Green Park Village | Phase 6

Additional Information to Support Design and Access Statement [for meeting 12.10.2017]

Appendix 1 – Response to DRP Comments #2

3D Massing Overview @ DRP#1

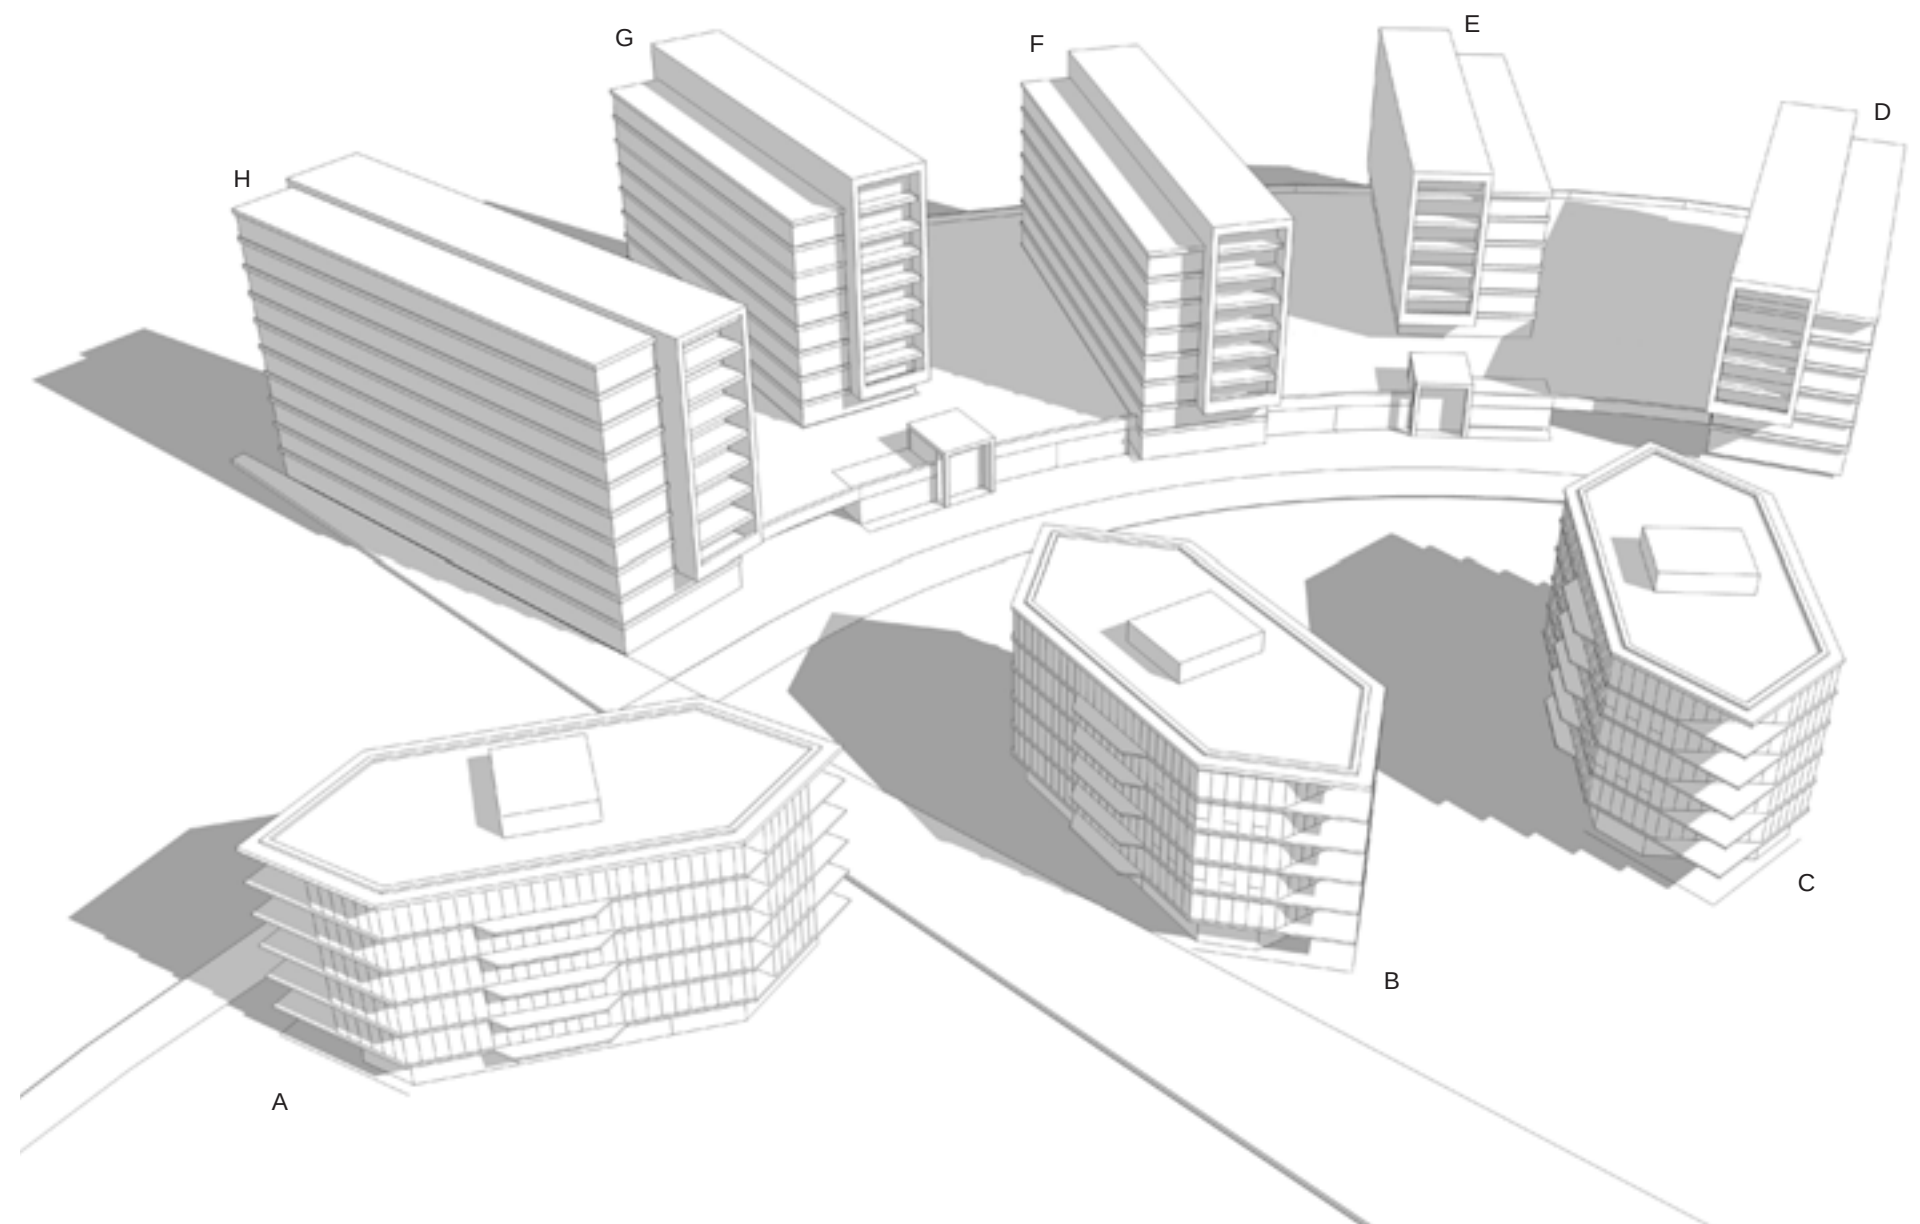
- General comfort with the overall extent of development
- Landscape detail is key
- Question sunlight to some spaces
- Review separation of Radial Blocks
- Explore 4 Radial Blocks instead of 5
- Blocks need to address areas beyond the site: How does the scheme address the Station?
- First steps are sound

- 7 Blocks (from 5 radial blocks to 4)
- 456 Homes (-40 Homes)
- Up to 12 Storeys (+1 to blocks G & H)
- Min. Distance Between Blocks 26m (+6m)
- Pavilions & Radial Blocks
- Parking under landscaped podium
- Sunlight Study undertaken
- +20% area to Landscape Podium gardens
- Landscape scheme developed
- New Station Gateway Square & Pavilion

Landscape masterplan showing podium connectivity

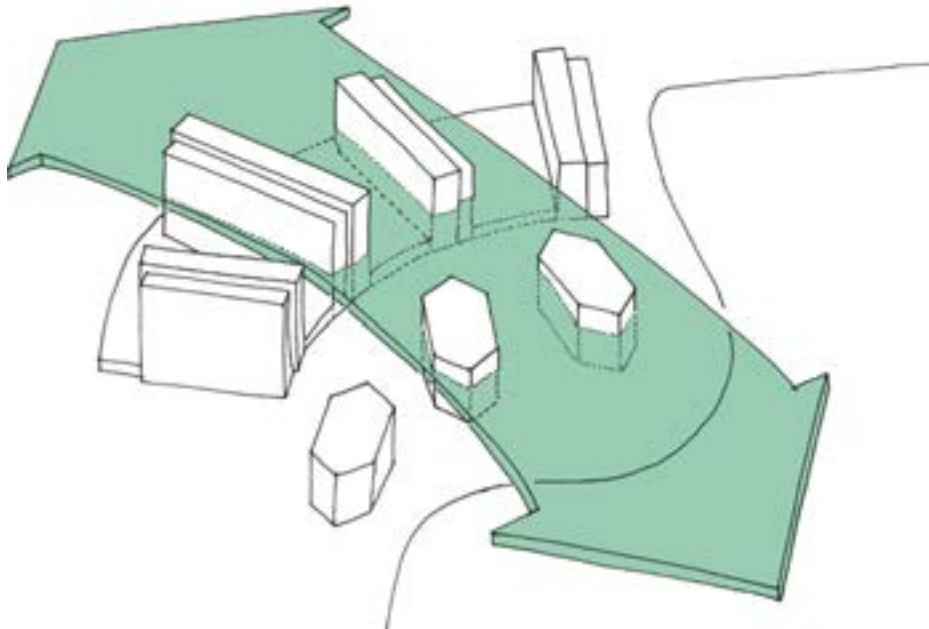
DRP Comment: *“Debate occurred with the applicant as to how the 3 courtyards between blocks D – G were interconnected and the level of accessibility that would be possible for residents of different buildings. The strategy for this needs to be developed further, the Panel were of the view that connectivity across the whole podium would benefit the scheme.”*

Design Response: The main entrances via the south facing primary cores will be the main circulation points (see blue arrows), from which access control will enable cross-podium circulation for residents should they wish to visit a separate podium garden. We feel this gives the connectivity across the podium as per the DRP request.

The landscape masterplan extracted from the DAS shown to the right shows the connectivity between podium gardens via access control through the primary cores indicated via pink arrows.

View looking north-west across Lake showing Pavilions in foreground and continuous landscape between Radial blocks

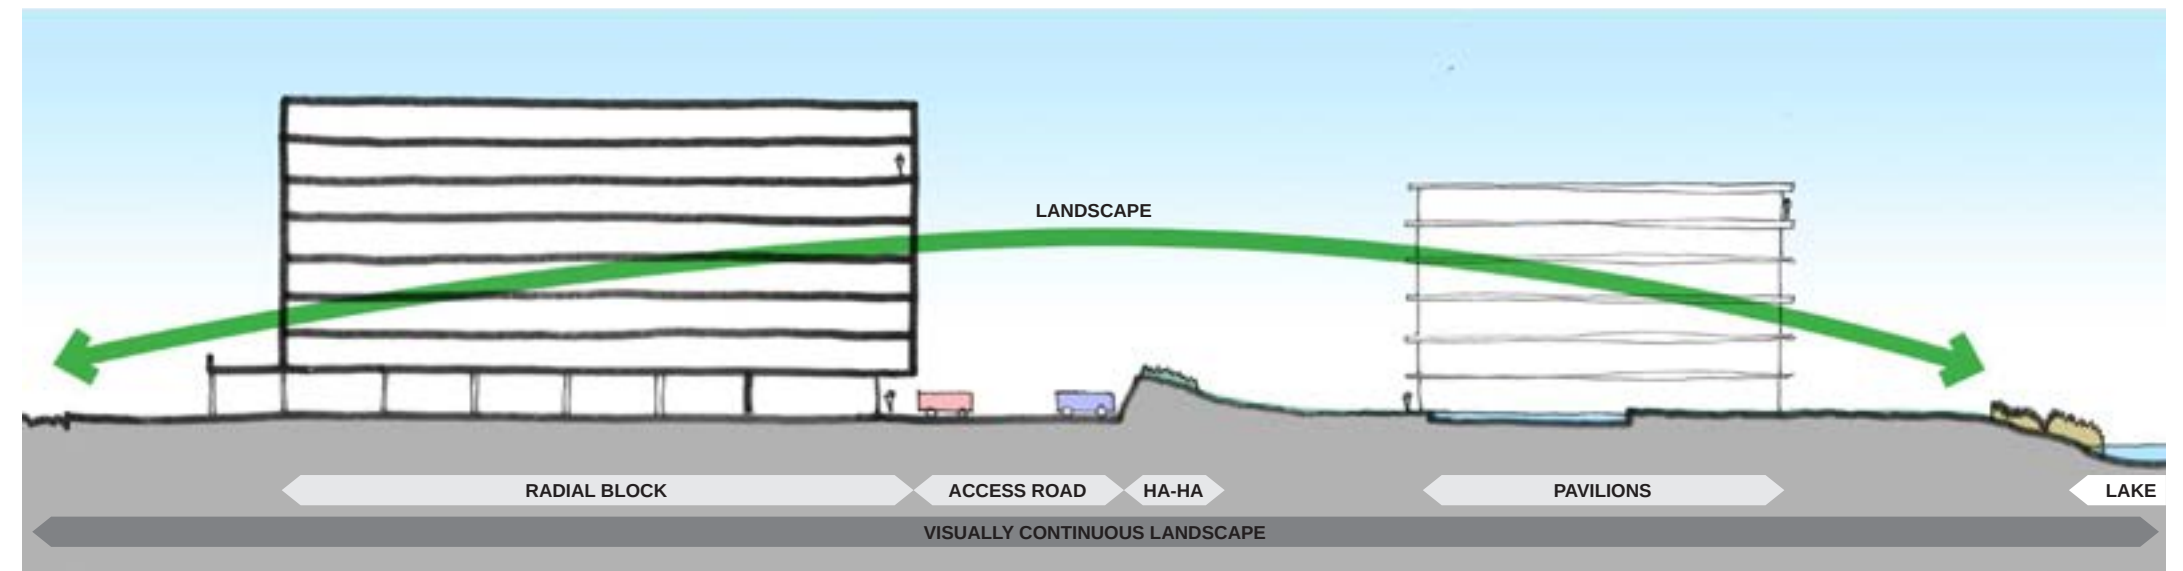
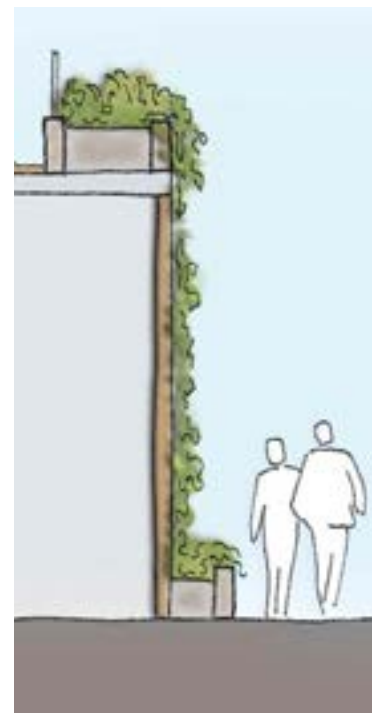
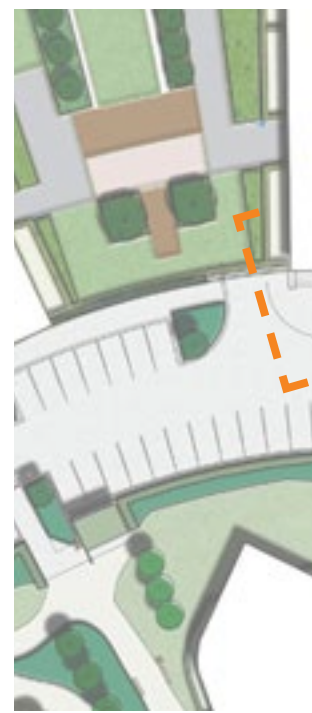
- Softening the edges where the two masterplan geometries meet, some blending of one into the other is needed.
- The car parking to block A, can this be included within proposals to the station square? The access to the car parking should be reviewed, it is very tight past the building presently.
- The parking along the main podium / entrance elevation needs softening and a sense of generosity.”

The images below and to the right illustrate how the podium edges have been softened and together with the ha-ha blend the landscape together.

They also demonstrate how planting has been introduced adjacent to the Crescent parking area to soften this space.

Radial Block Material Location Plan

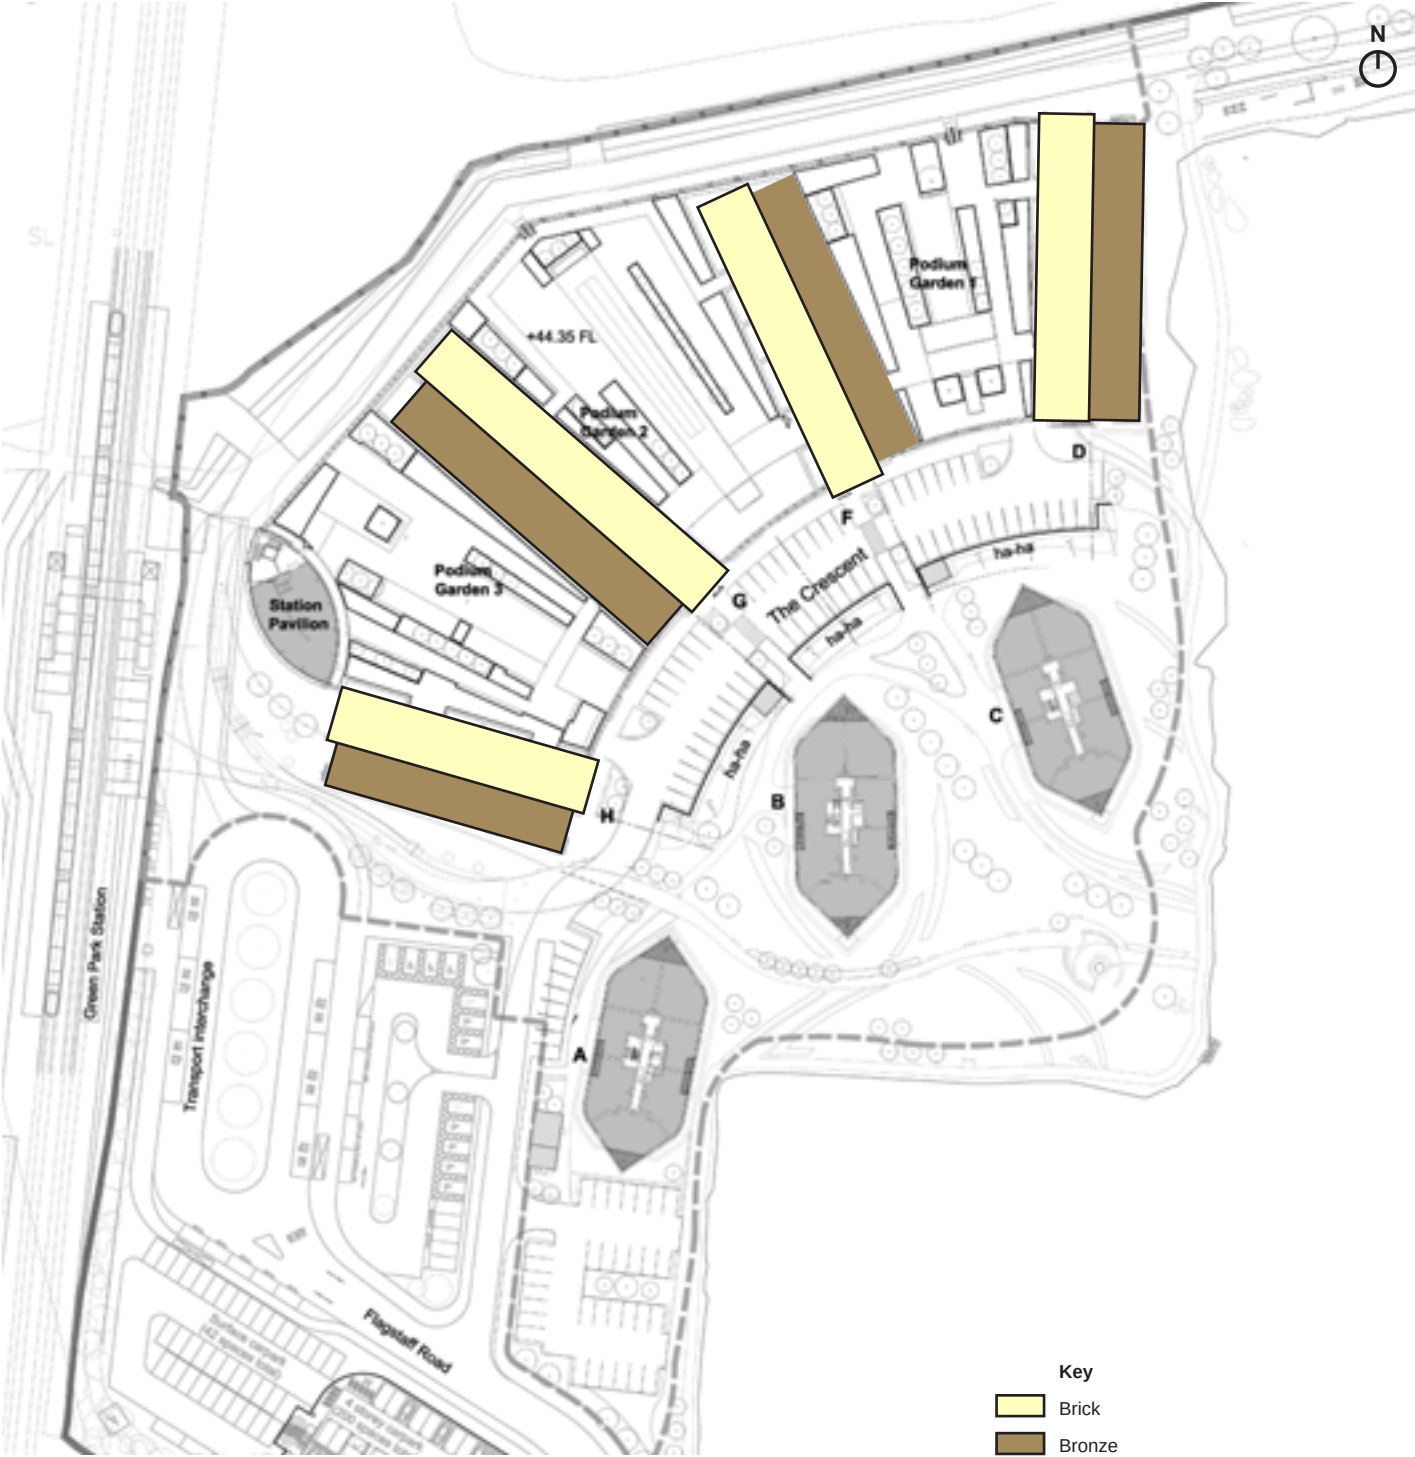
DRP Comment: “If the buildings are really ‘spokes on a wheel’ why do the brick and metal clad elements change side, surely that principle should be consistent?”

Design Response: As identified earlier, the longitudinal step is orientated to respond to the aspect of each block (roof terraces) and the edges of the site (station & lakeside). Therefore their orientation is rational. In addition, this gives each podium garden its own elevation character: brick/bronze, brick/brick, bronze/brick.

The plan to the right shows how the bronze elements address the Station Square & the Lake Edge.

Materials comparison schedule

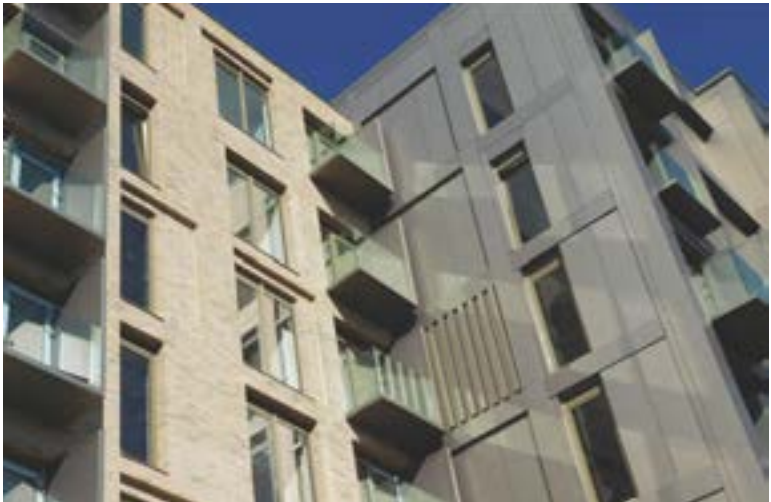
DRP Comment: “Blocks D – G the latest iteration of the appearance is a poor relation to the first ideas presented. Whilst the idea of buildings conceived as two partners is interesting and the end elevations have a slender elegance and long flank elevations are too monolithic.

The precedents and aspirations being presented are simply not good enough. Reading has a rich ‘brick’ heritage it seems a missed opportunity this is not being referenced in one of the biggest brick developments in the town.

With regard to materials whilst these were not formally proposed, again development and rigour behind the proposals is needed. It would be nice to see brick tones prominent within the architecture of Reading considered.”

Design Response: In the context of the precedents comment, we do not concur with the Panel. The materials palette proposed is consistent with that regularly used by the architectural firms given as examples above. The materials comparison schedule to the right (taken from the DAS) identifies the architectural qualities of the contrasting material selection on the radial blocks (D-H).

Typical edge section through Pavilion

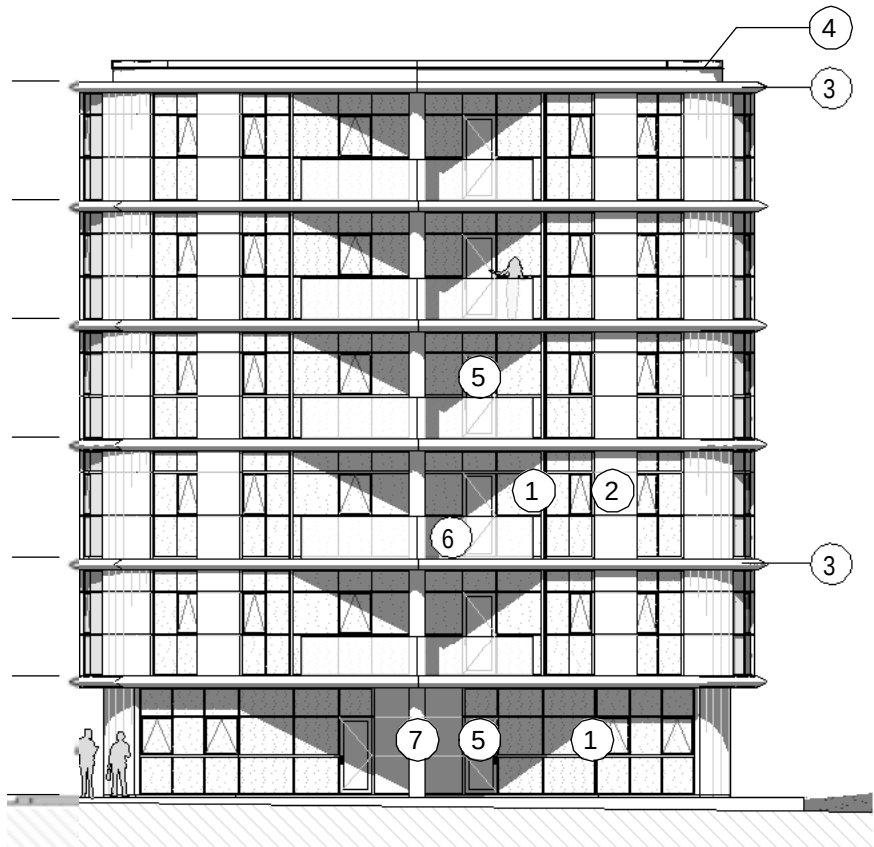
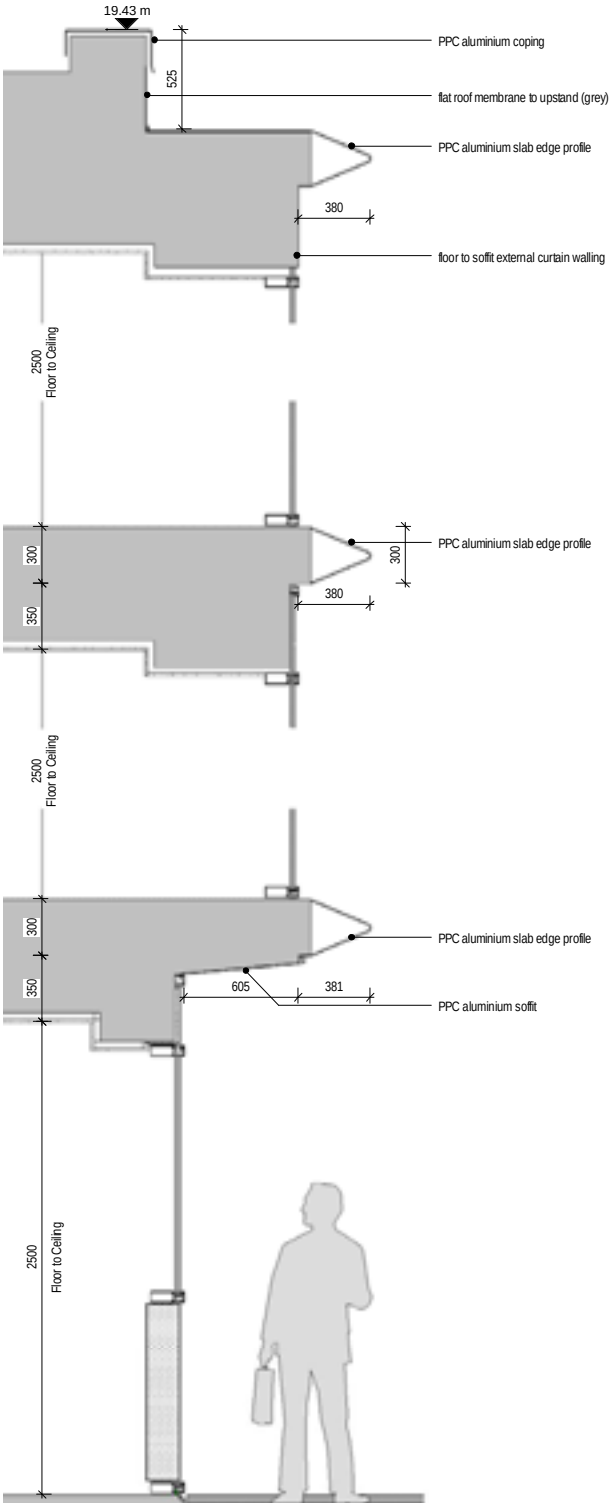
DRP Comment: “Blocks A – C also need considerable work, the buildings have a commercial feel currently not the lightweight pavilions described.”

Design Response: The Pavilions are designed to contrast with the radial blocks, the schedule below identifies the key architectural differences between the blocks:

The elevations are clad in glass which will give a lightweight appearance. The submitted imagery and drawings to the right illustrate these principles.
